#	Date	Source	Name	Comment
1.	9/2/2025	Email	Randy M., PE, PTOE	<p>Just read your supplement....a couple things to think about.</p> <ol style="list-style-type: none">1. 25B-RW-01 and 25B-MKG-01 both are being reviewed by sponsors addressing lane drop and lane reduction issues - fyi (see attached)2. Working with OSU we did some research on the stop line in advance of a marked crosswalk at a signal (see attached) - this is in review at TRB for potential presentation at the 2026 annual meeting3. 24A-PED-02 was approved by council related to Section 4F.19 and pedestrian change interval (attached)4. 25A-RW-01 addressed school when flashing and was approved by Council June 2025 (see attached) <p>Randy [see attachments]</p>
Follow-up	9/15/2025	Email	Randy M., PE, PTOE	<p>Hi Eric -</p> <p>Hope you are doing well. I have attached my comments to the draft Oregon Supplement to the MUTCD. It focuses on the removal of the colored LRT signal indications (which were a part of the 2009 supplement). I understand the situation that FHWA has created for ODOT and this topic but felt it was important to comment. Safety issues of this type should not be taken simply as compliance issues unless research

Figure 2C-13. Example Sequences for Lane Ends and Lane Merge Signs (Sheet 1 of 5)

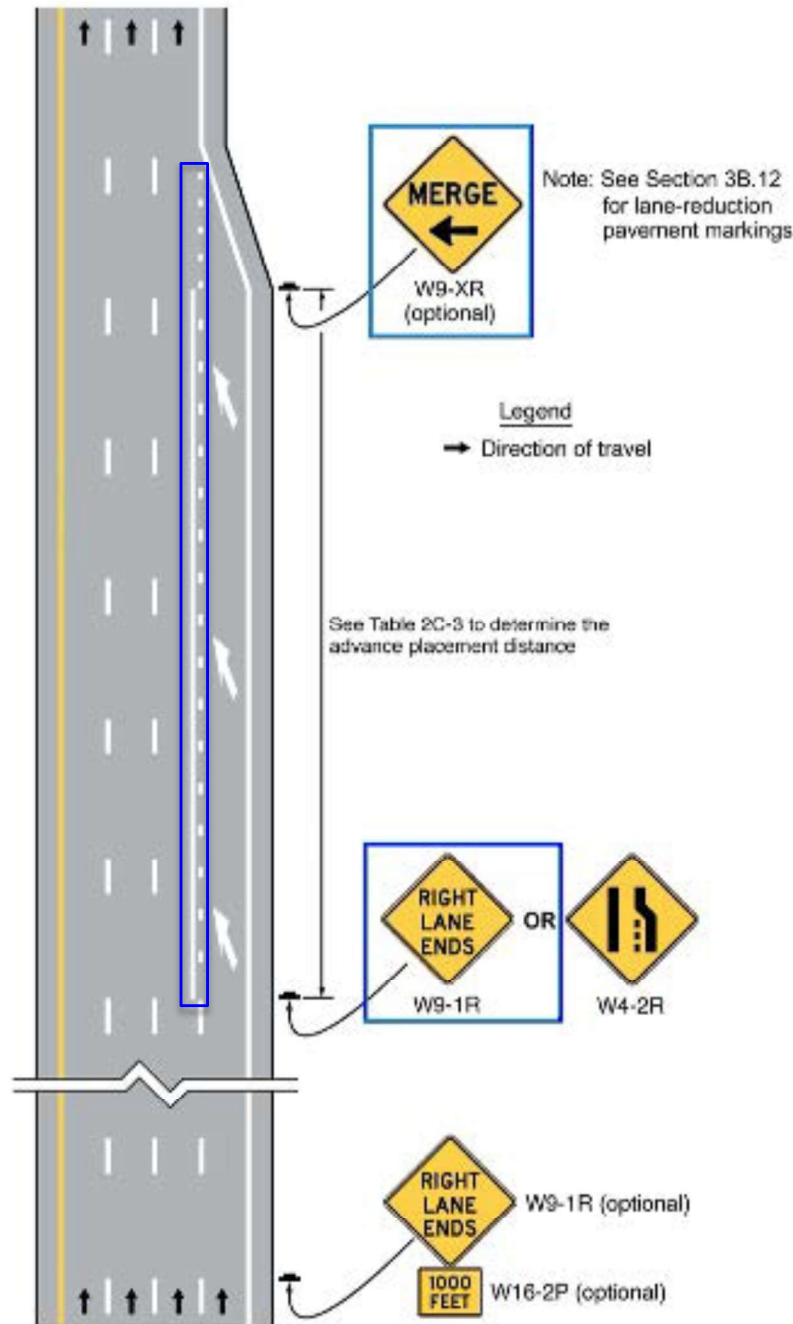
1. Added W9-1R sign at conforming advance placement location
2. Added optional W9-XR MERGE with arrow sign at beginning of taper
3. Interim depiction of pavement marking patterns and lane reduction arrows reflect existing content in the MUTCD that is harmonized with research results with the addition of the solid line consistent with the research report. These depictions are subject to change pending Council approval of the MTC proposal addressing this research.

Figure 2C-13. Example Sequences for Lane Ends and Lane Merge Signs (Sheet 2 of 5)

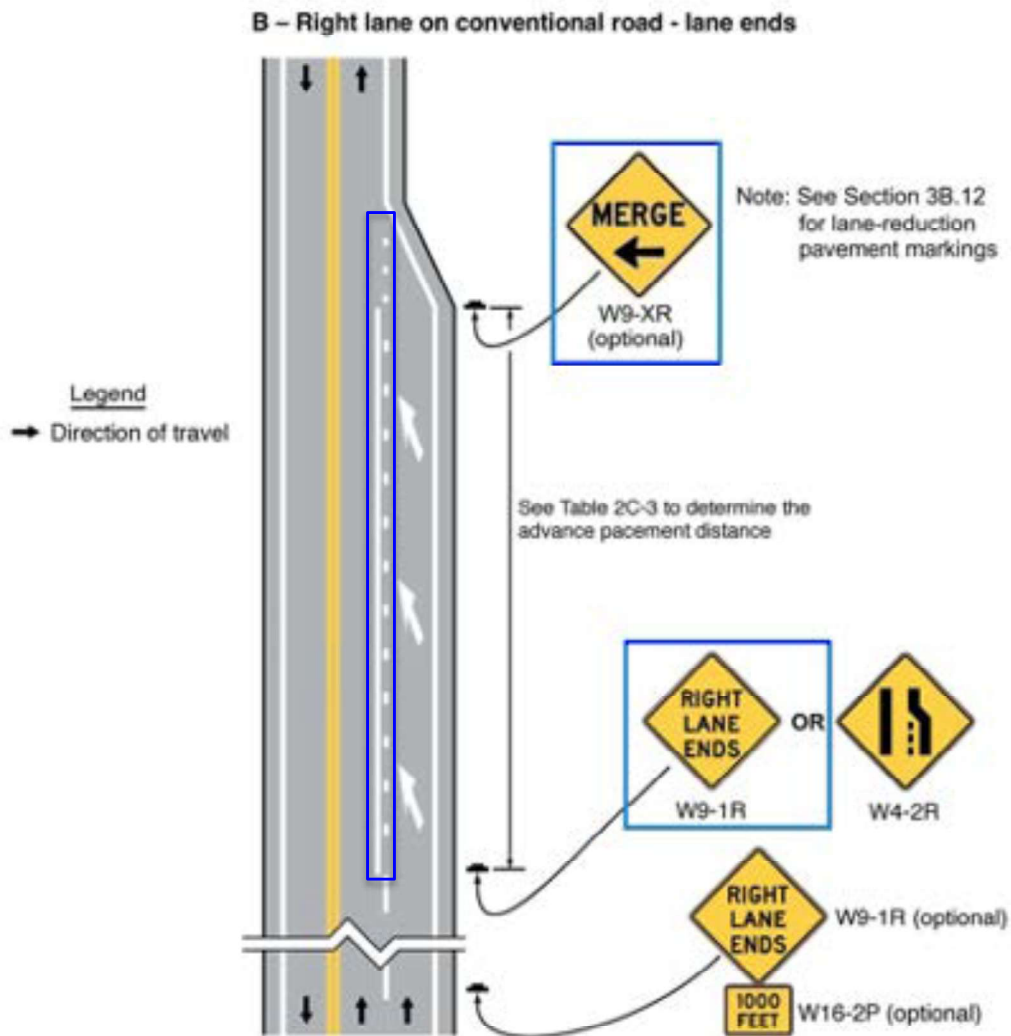
1. Added W9-1R sign at conforming advance placement location
2. Added optional W9-XR MERGE with arrow sign at beginning of taper
3. Interim depiction of pavement marking patterns and lane reduction arrows reflect existing content in the MUTCD that is harmonized with research results with the addition of the solid line consistent with the research report. These depictions are subject to change pending Council approval of the MTC proposal addressing this research.

Figure 2C-13. Example Sequences for Lane Ends and Lane Merge Signs (Sheet 3 of 5)

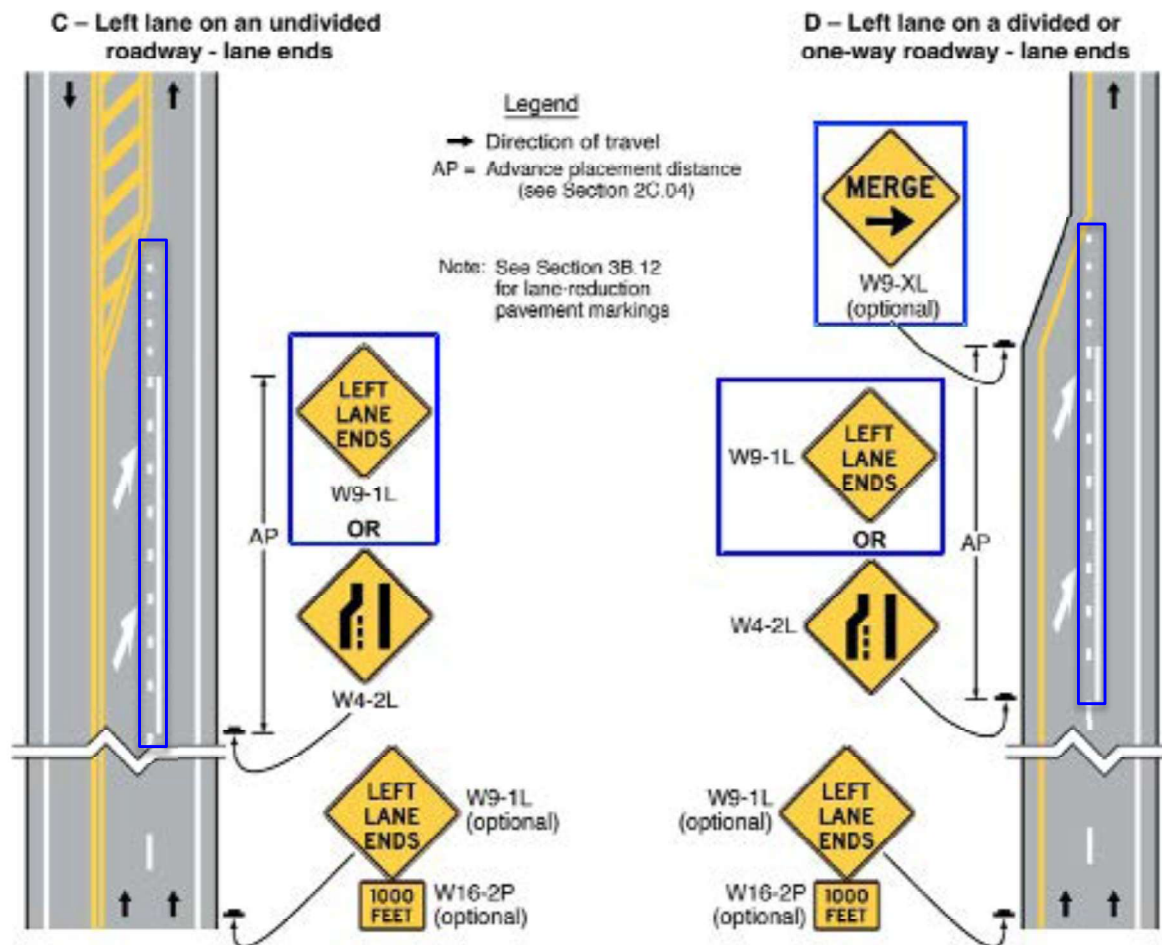
1. Added W9-1L signs at conforming advance placement locations.
2. Added optional W9-XL MERGE with arrow sign at beginning of taper in Depiction D only.
3. Interim depiction of pavement marking patterns and lane reduction arrows reflect existing content in the MUTCD that is harmonized with research results with the addition of the solid line consistent with the research report. These depictions are subject to change pending Council approval of the MTC proposal addressing this research.

Figure 2C-13. Example Sequences for Lane Ends and Lane Merge Signs (Sheet 4 of 5)

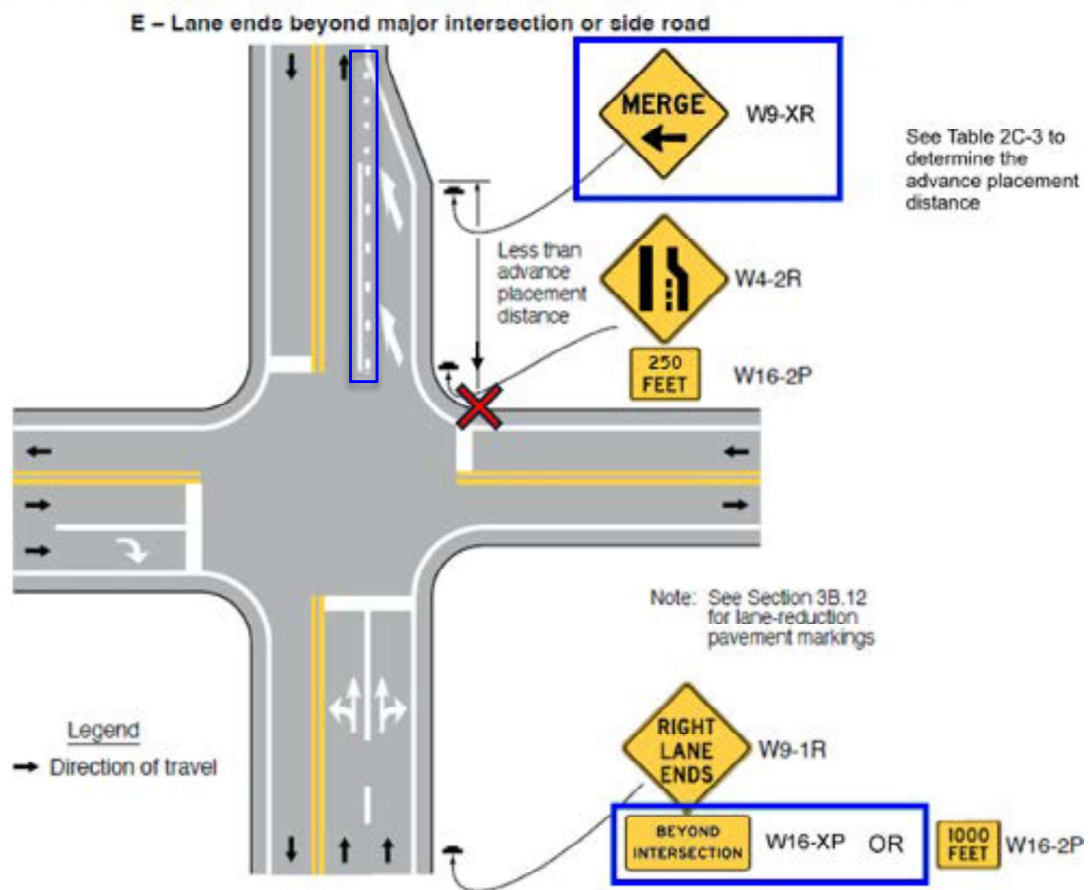
1. Added recommended W16-XP "BEYOND INTERSECTION" plaque beneath W9-1R sign with alternative of W16-2P distance plaque.
2. Added recommended W16-2P distance plaque beneath W4-2R sign.

3. Added optional W9-XR MERGE with arrow sign at beginning of taper.
4. Corrected dimensioning line between W4-2R sign and beginning of taper to place the upstream arrow adjacent to the location of the warning sign and not the projection of the traveled way

5. Altered the distance shown in the plaque so that it is less than a typical advance placement distance for low-speed roadways, to match the circumstances where this sign would be used

6. Interim depiction of pavement marking patterns and lane reduction arrows reflect existing content in the MUTCD that is harmonized with research results with the addition of the solid line consistent with the research report. These depictions are subject to change pending Council approval of the MTC proposal addressing this research.

Figure 2C-16. Supplemental Warning Plaques

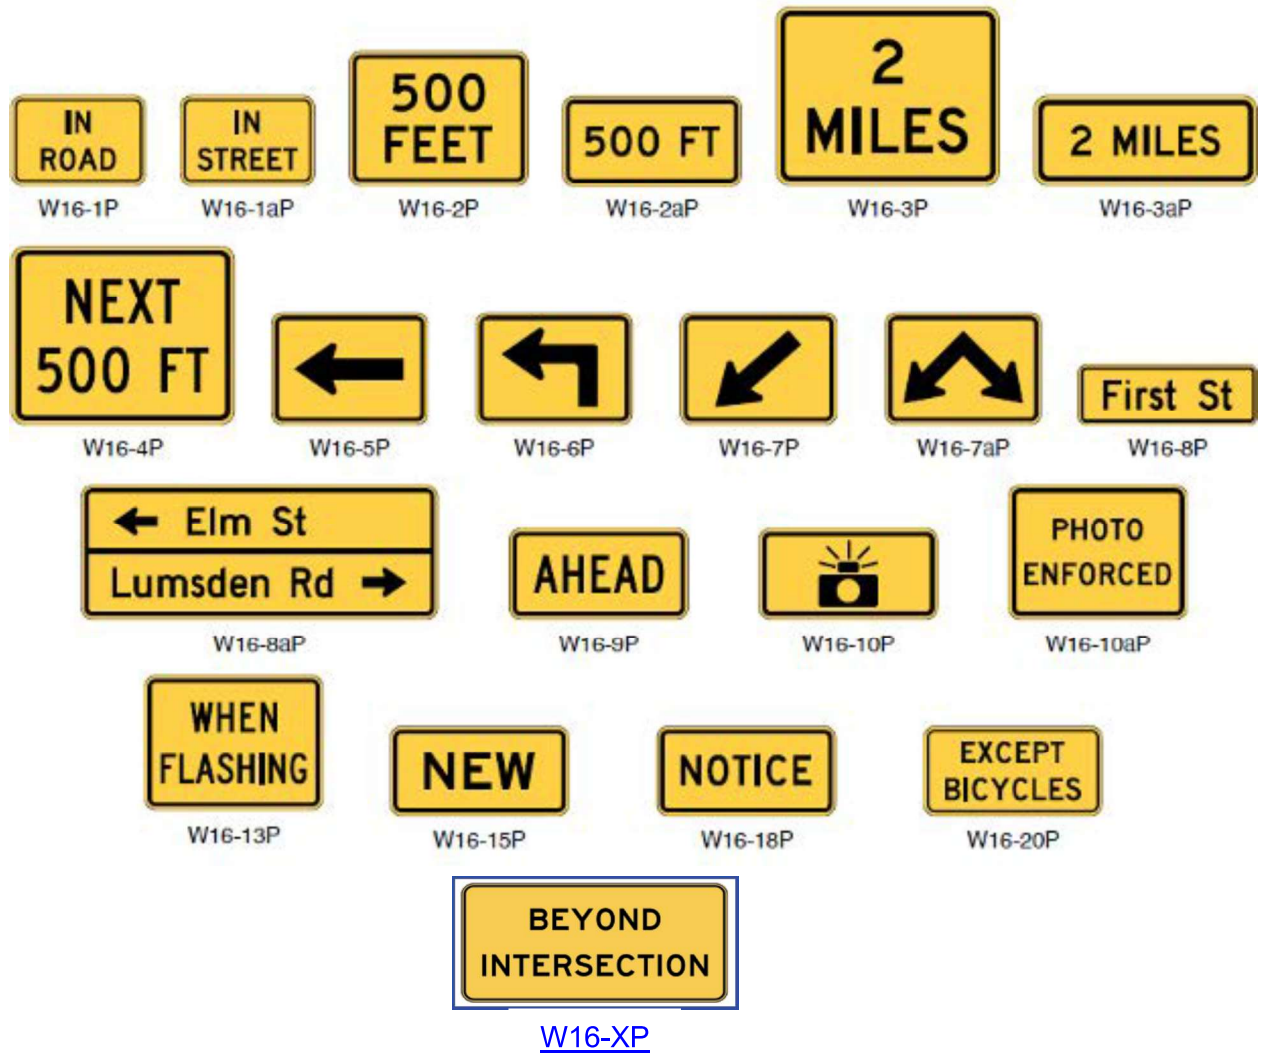
1. Added W16-XP "BEYOND INTERSECTION" plaque.
